Historic Architectural Review Commission Staff Report for Item 3

Address: #643 William Street

Description of Work:

Demolition of non-historic wood frame shed. Removal of wall of historic rear addition.

2 SITE PLAN - DEMO
A 1.0 1/8" = 1'-0"

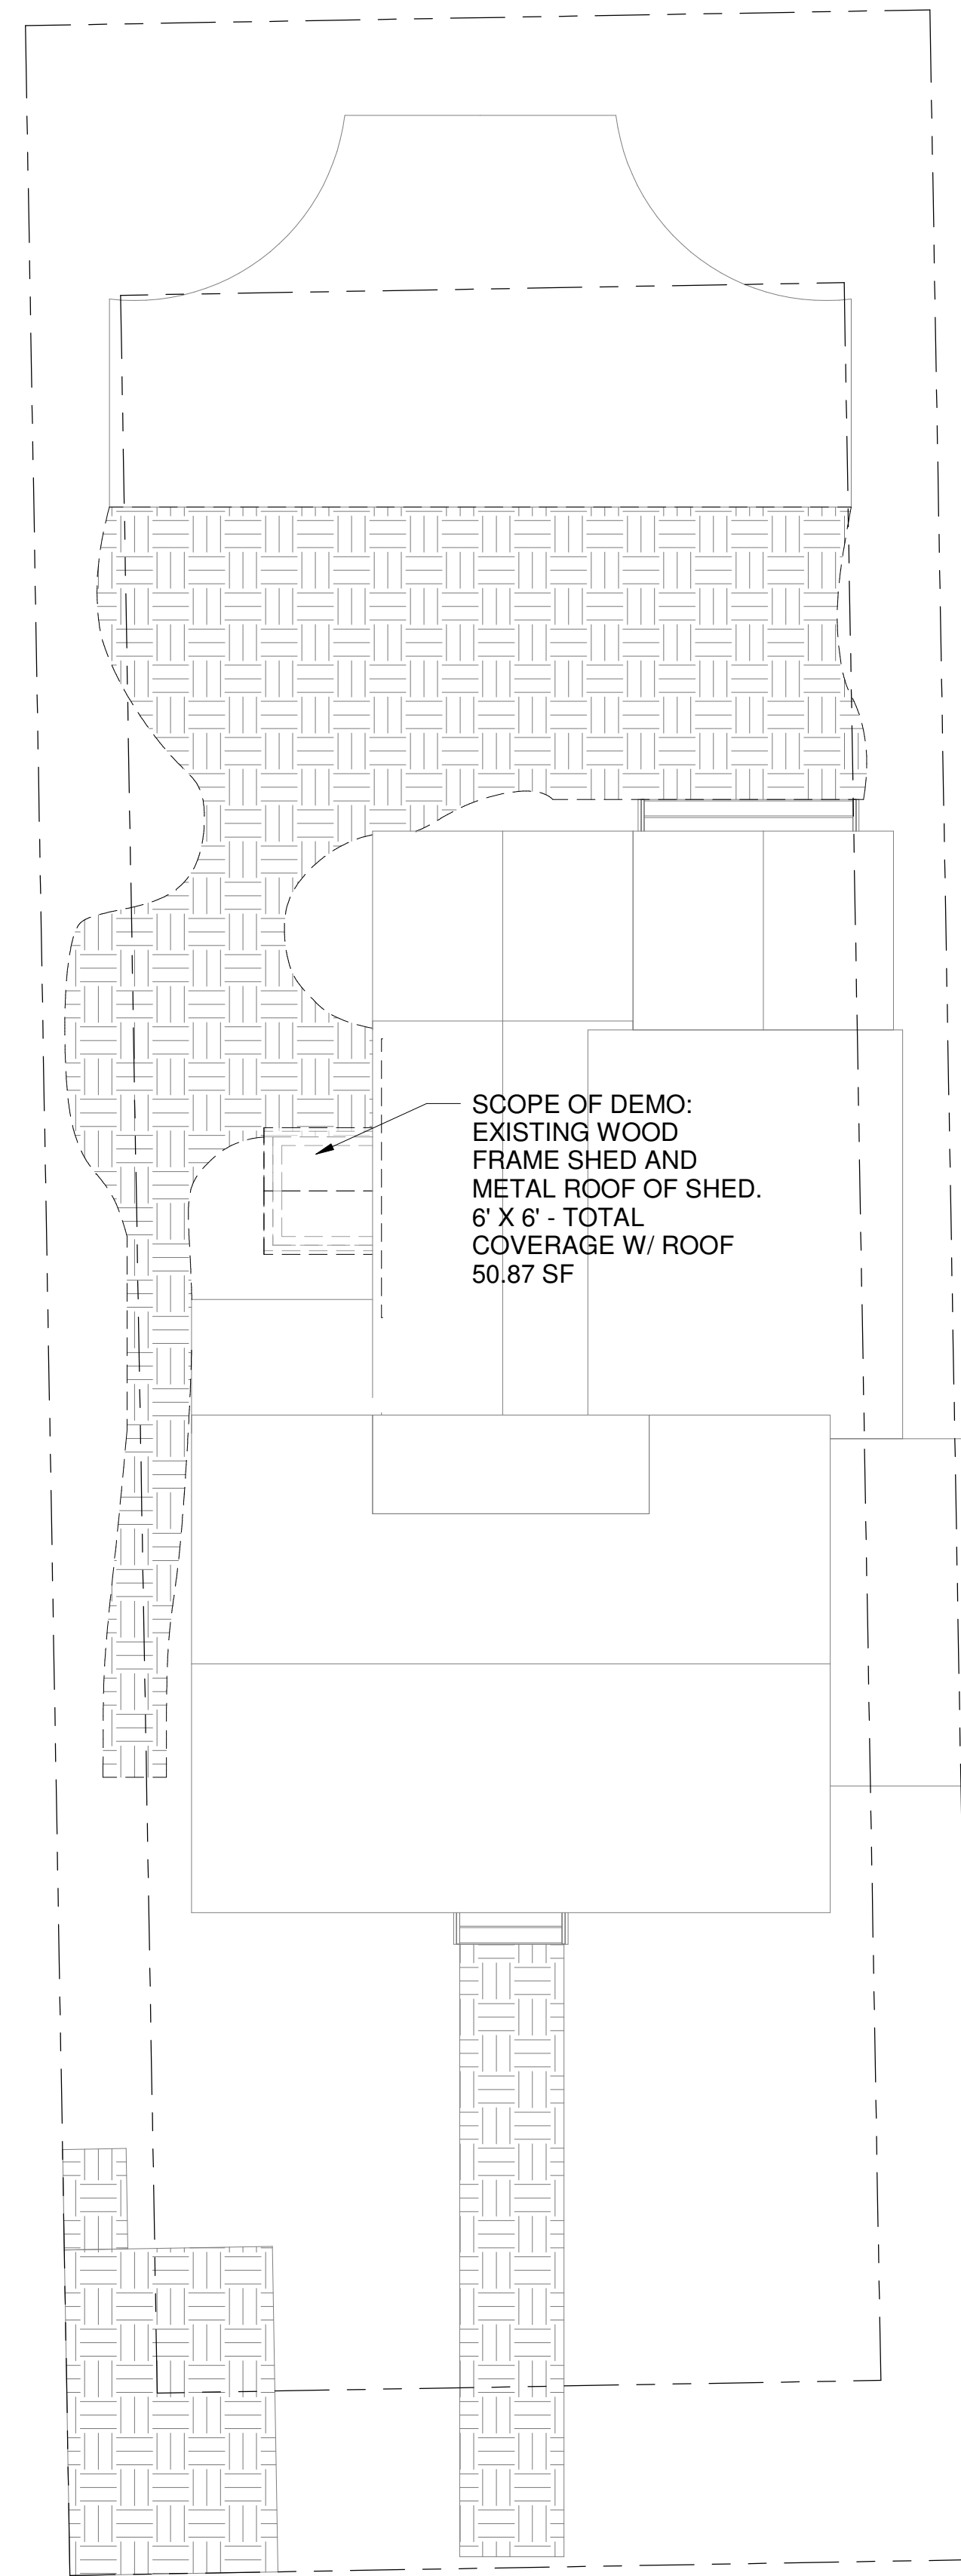
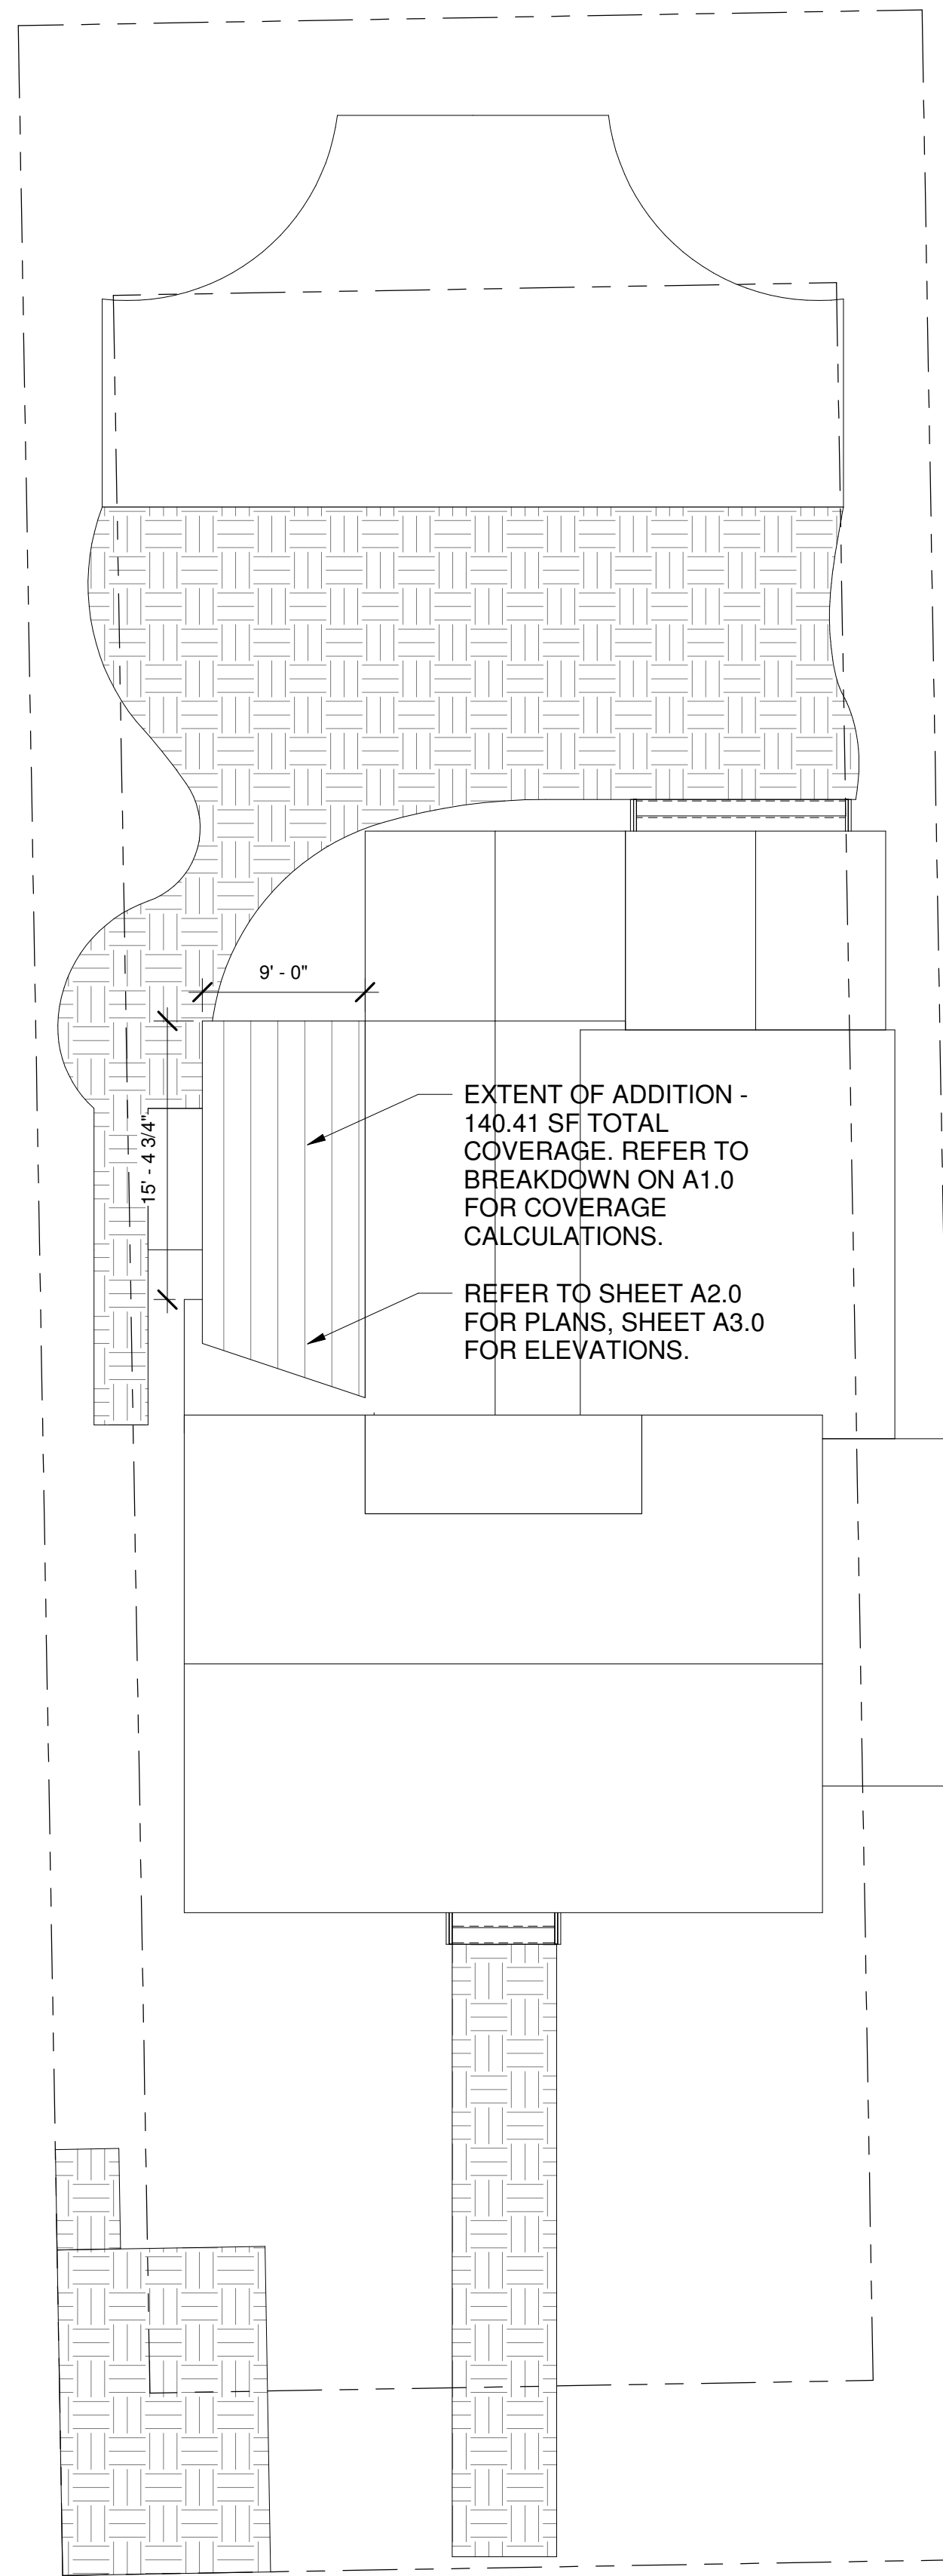
The Certificate of Appropriateness under review proposes the demolition of an existing non-historic wood frame shed at the rear of the house at 643 William Street. The demolition would also include the removal of a wall of a historic addition, which extends from the rear center of the house. The proposed demolition would allow for the construction of a new one-story shed roof addition. The design of the shed roof addition was approved at the HARC meeting on August 24th, along with the first reading of demolition.

It is staff's opinion that the request for the demolition of the wall of the historic rear addition shall be based on the demolition criteria of Chapter 102 Section 218(a) of the LDR's. The criteria state the following;

The wall of the historic rear addition in question does not meet the criteria in section 102-125.

Staff finds that the wall embodies no distinctive characteristics of aesthetic or historic significance. The historic rear addition has already been obscured by previous additions and the wall in question has no individual distinction.

It is staff's opinion that the Commission can review the request for demolition. If approved, this will be the final required reading for demolition.
